DOWNTOWN WATERFRONT CORROSION CONTROL REPAIRS

Contract No. E16-164

ADDENDUM NO.: THREE

February 23, 2016

MARINE PARK ELEVATION PHOTOS

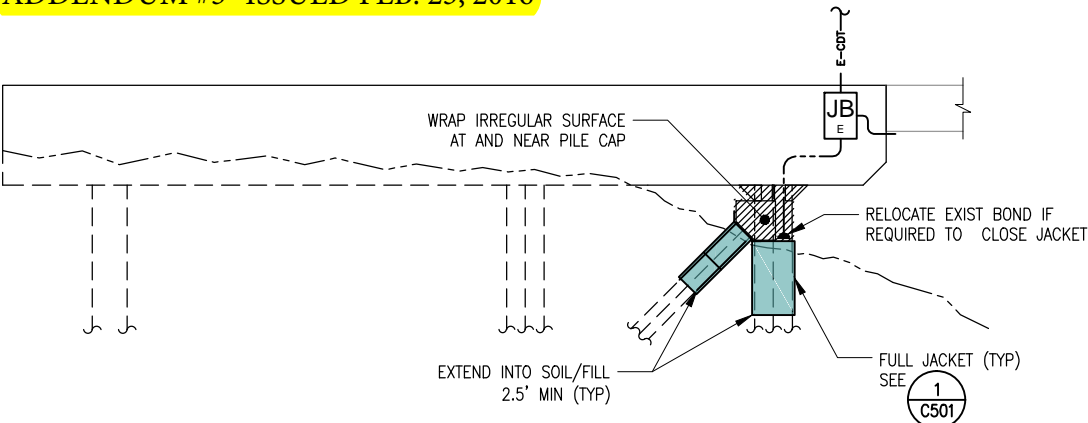
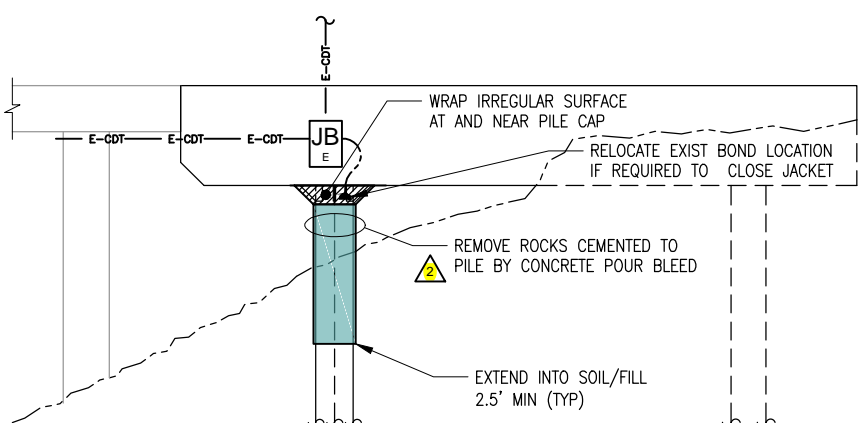
16. Sheet C501 – It appears there is a cap on top of the pile jacket to hold in the foam but it is not referenced.
Response: There is no cap
17. Sheet C204 – Please confirm if recoating is necessary and provide an estimated square footage for equal bidding.

18. Sheet C204 has been revised to delete the coating notations.
19. Sheet C004 – Please confirm the quantities of pile jackets in the BOM and their length. See revisions to Sheet C004.

1	02/12/16	DELETE COATING CALLOUT	JST
No.	DATE	DESCRIPTION	BY

5 ELEVATION - "E.5" LINE PILINGS
SCALE: NTS

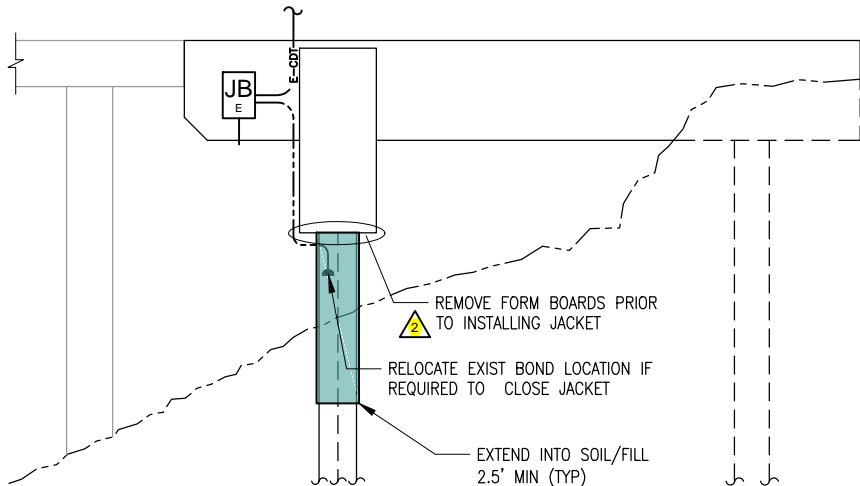
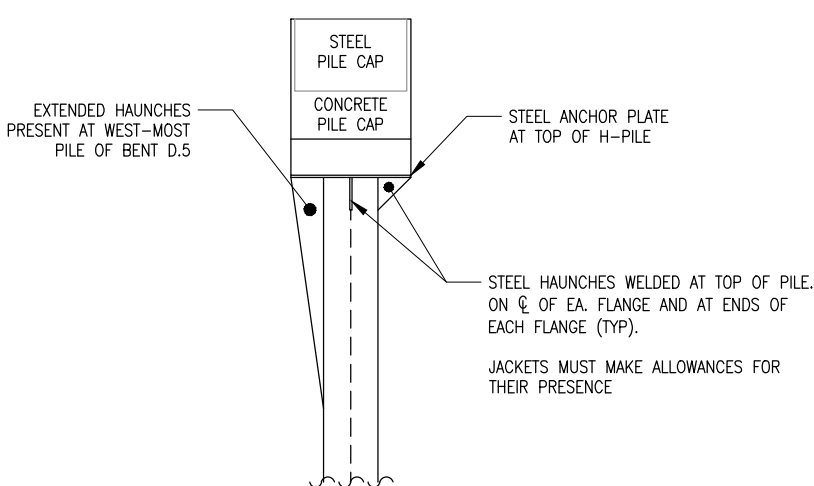
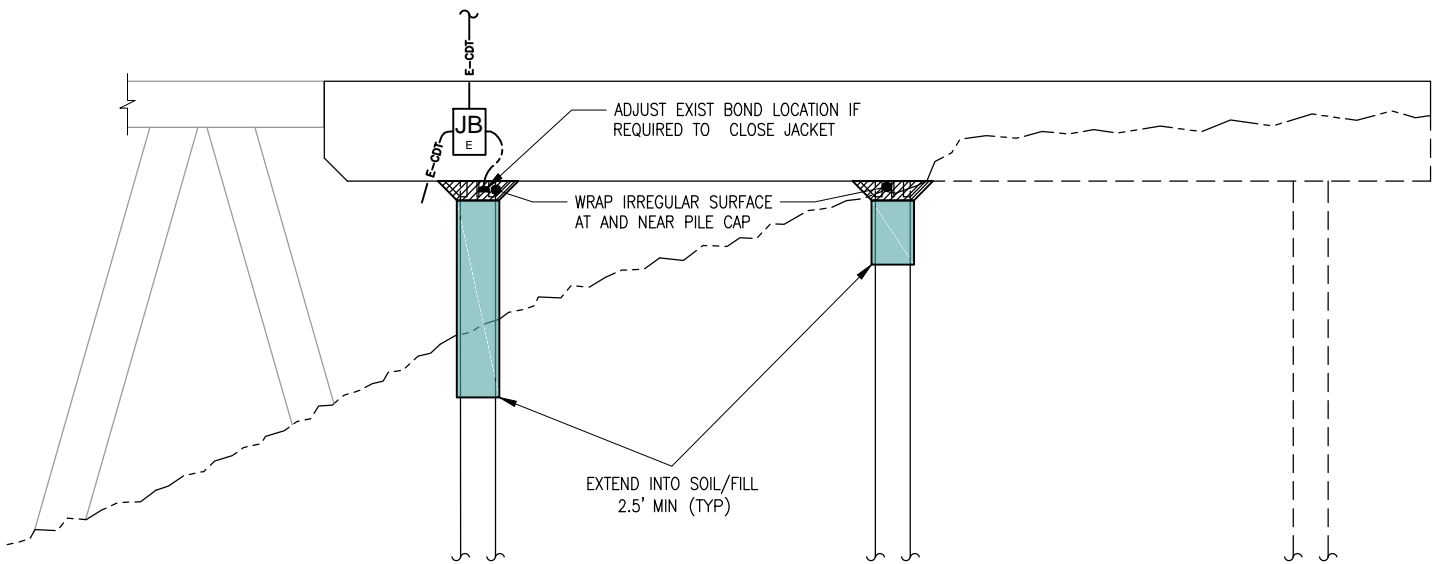
1. "C004 – Pile Schedule – 1 jacketed, sheets 301/302 shows 2 piles. Which is it?"
Response: Changed C004 Add 2 dwg to show 2 piles to agree with Line E.5 shown on sheet C302.
2. "C302 – E.5, will bidder need to go down 4' or can we go down to 3'?" Believe the question related to the specs, 02455, 3.5 F 3a, that said no jackets could be shorter than 4'.
Response: Changed the spec to allow for this.
3. "What are the work hours?"
Response: Article 6 – 6.19 in the General Conditions (Page 00700-23) specifies the work hours and limitations. Per Section Work Hrs. 7am-10pm or by application to CBJ Community Development Department's permit officer for work outside these times.
4. "02455 Pile Wrap Jacketing – B – 7 – is third party coating inspector required?"
Response: No, a coating inspector will not be required. Deleted that and B1c, but kept 1.3 MFR's Representative.

Response: Harbors has provided that to me. It's a 30'x45' float and the max working load we're comfortable with is 50lbs/sf.
11. On Sheets C302 & C303 –What is the size of the existing bond wires that may have to be relocated?

Response: Refer to As-Built drawings, provided on CBJ Engineering Contract's website.
12. Can we use a mechanical connection or does the relocated wire need to be exothermically welded?

Response: Exothermic welds. Sheets C302 & C303 have been revised.
13. Is there an estimated number of existing bonds that will need to be relocated in order to bid equally?

1	02/12/16	REVISE NOTES	JST
2	02/12/16	ADD CALLOUT	JST
No.	DATE	DESCRIPTION	BY

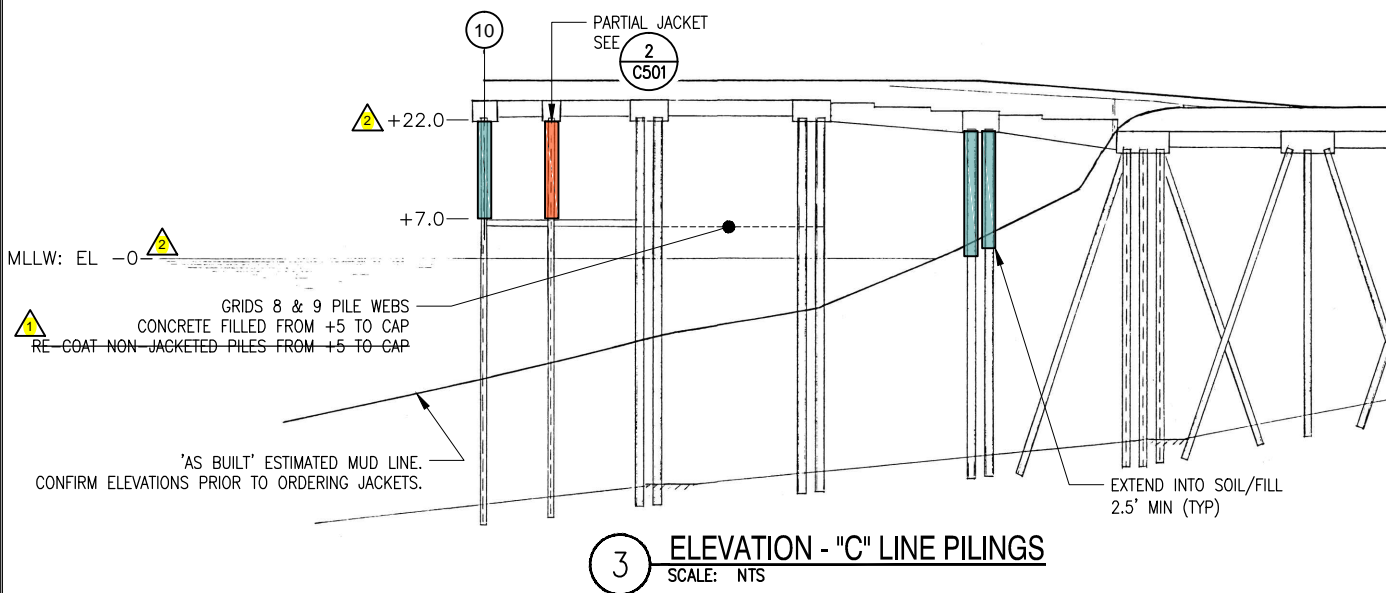
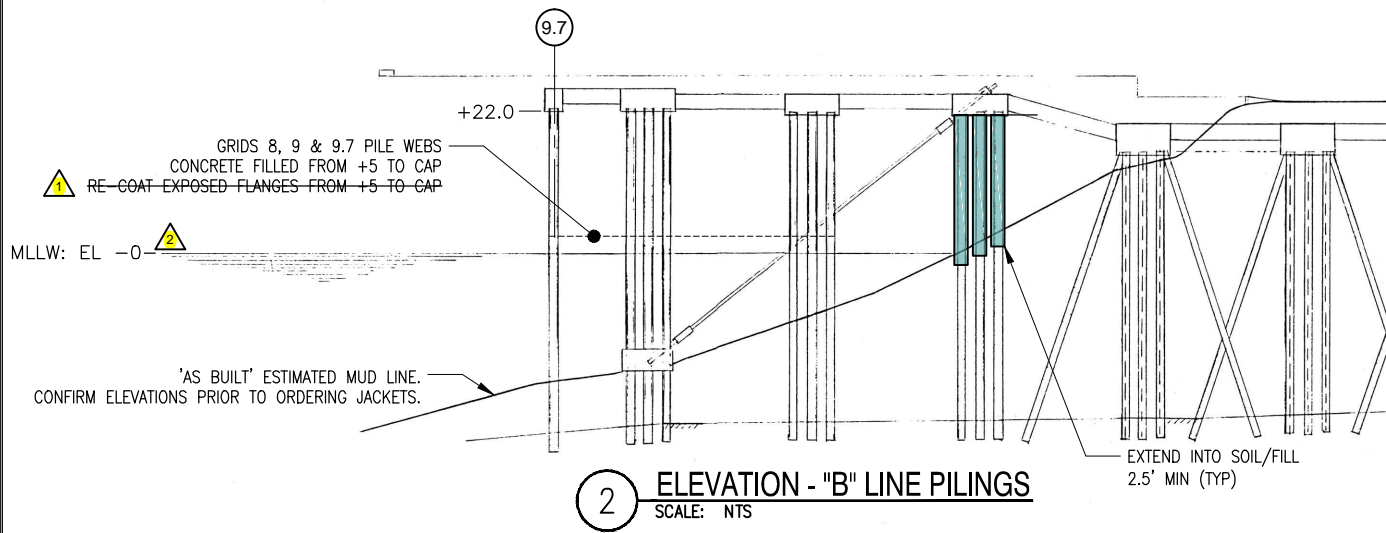
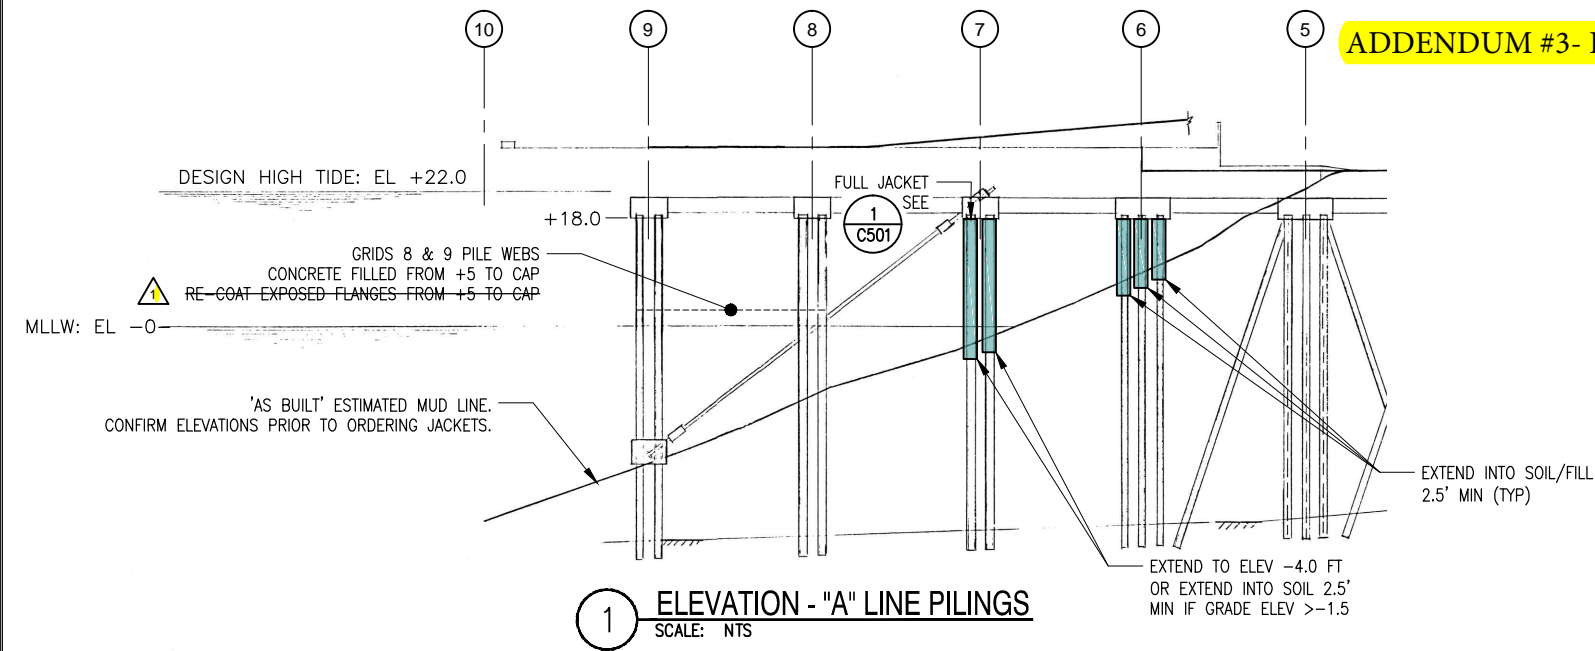
Response: No, depends if they will create a problem with proper installation of the jacket as configured by the Contractor.
14. Sheet C402 – Please clarify if coating is of exposed flanges and non-jacketed piles is required.

Response: Sheets C402 & C403 have been revised to delete the coating notations.
15. Sheet CP101 – Please confirm length of anode sled, plans show 74' and not 74".

REVISIONS			
1	02/12/16	DELETE COATING CALLOUTS	JST
2	02/12/16	REVISED ELEVATION NOTATIONS	JST
No.	DATE	DESCRIPTION	BY

1 ELEVATION - "C.5" LINE PILINGS
SCALE: NTS

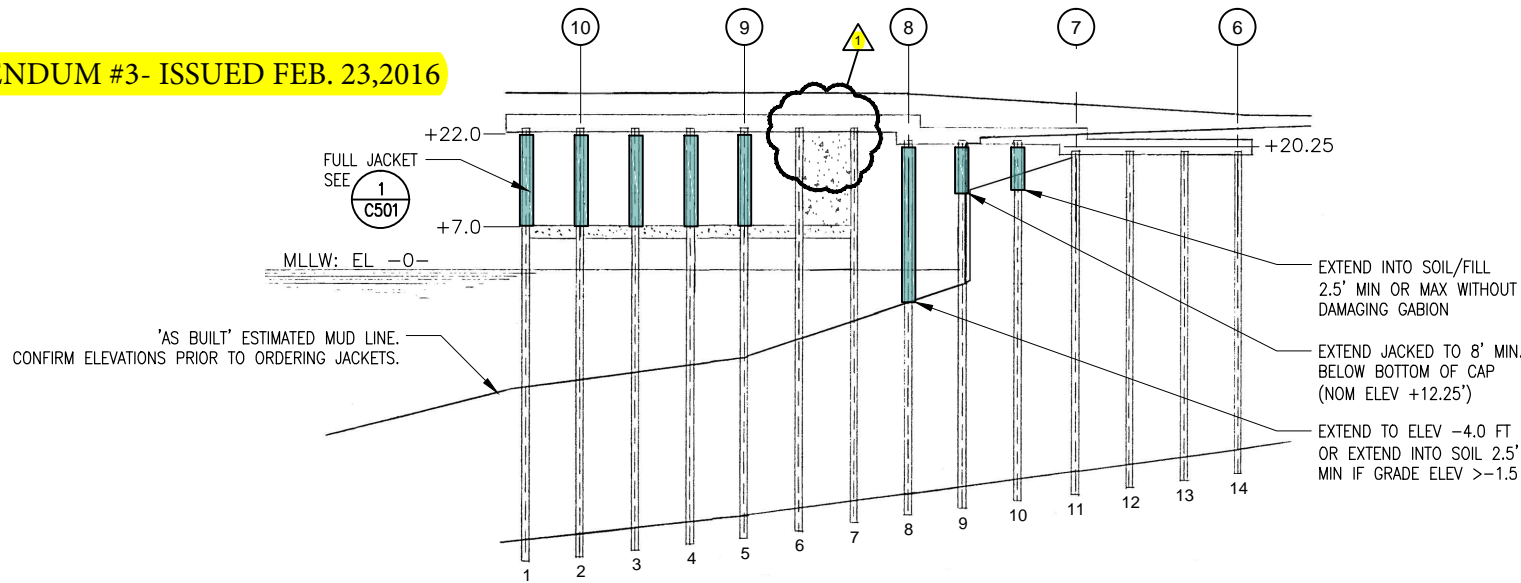
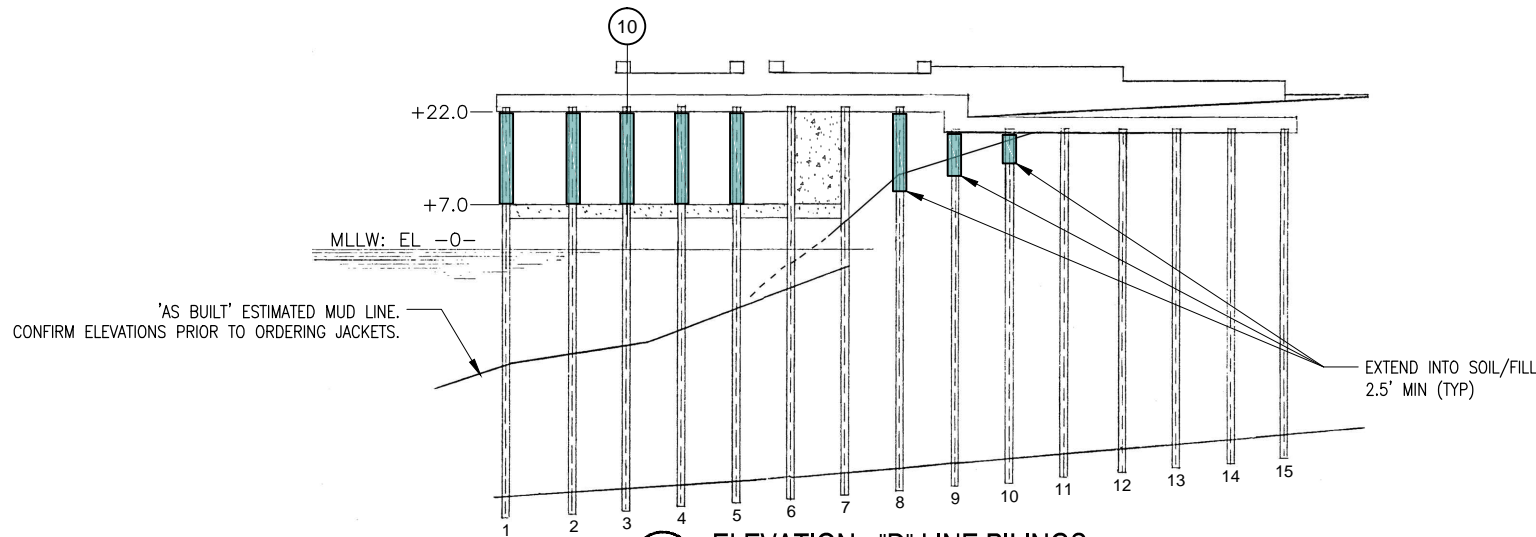
6. C403 – Elevation 1 – said we would remove the requirement for the re-coat of all flange faces.
Response: The coating notation is deleted on C403.
7. Depth on digging – cluster piles. I believe we noted the downhill pile as the point of reference.

9. Do we need to further clarify that gabion wall is not to be touched on pile 10 to get the 2 ½ feet?
Response: See revised notes on C403.
10. Load limits on lightering dock?

1	02/12/16	DELETE COATING CALLOUT	JST
2	02/12/16	REVISED NOTES	JST
No.	DATE	DESCRIPTION	BY

CP101

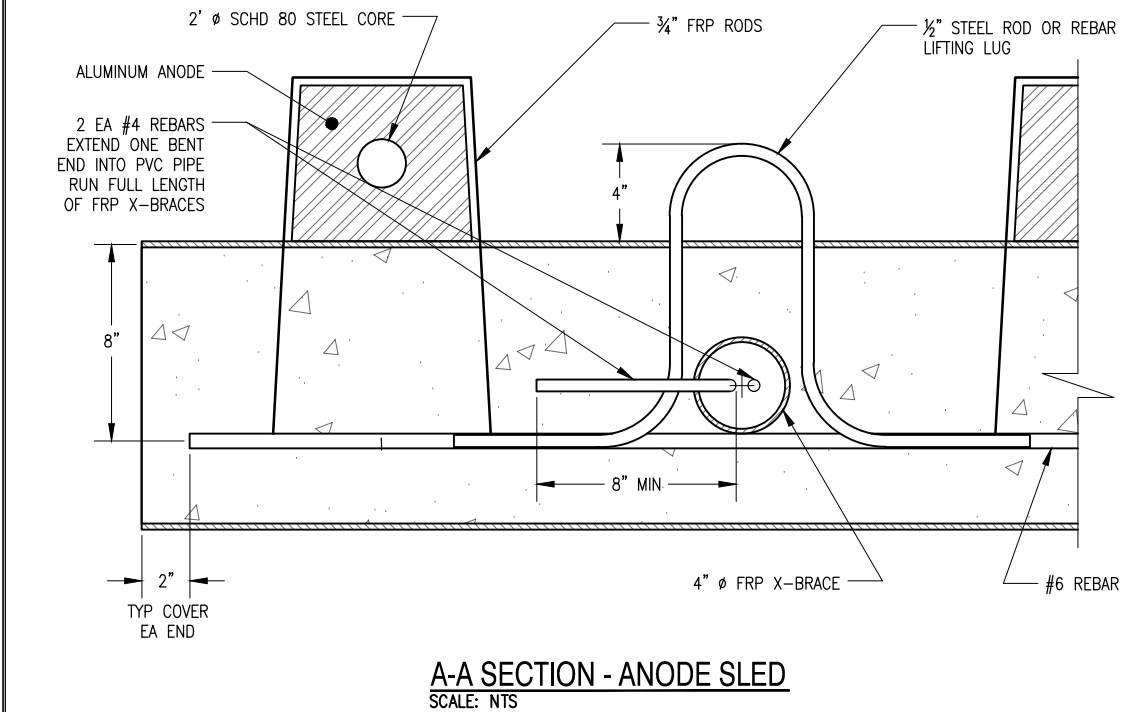
22. MESA is proposing an alternate sled design that would include 5 aluminum anodes @ 175# each for a total of 875 lbs, so that we can utilize an existing frame design. See attached example. Would this be acceptable?

Response: 74" is correct, Sheet CP101 has been revised.

Response: That mod would be okay. Added note to Detail 1 of CP101 re: dim changes.
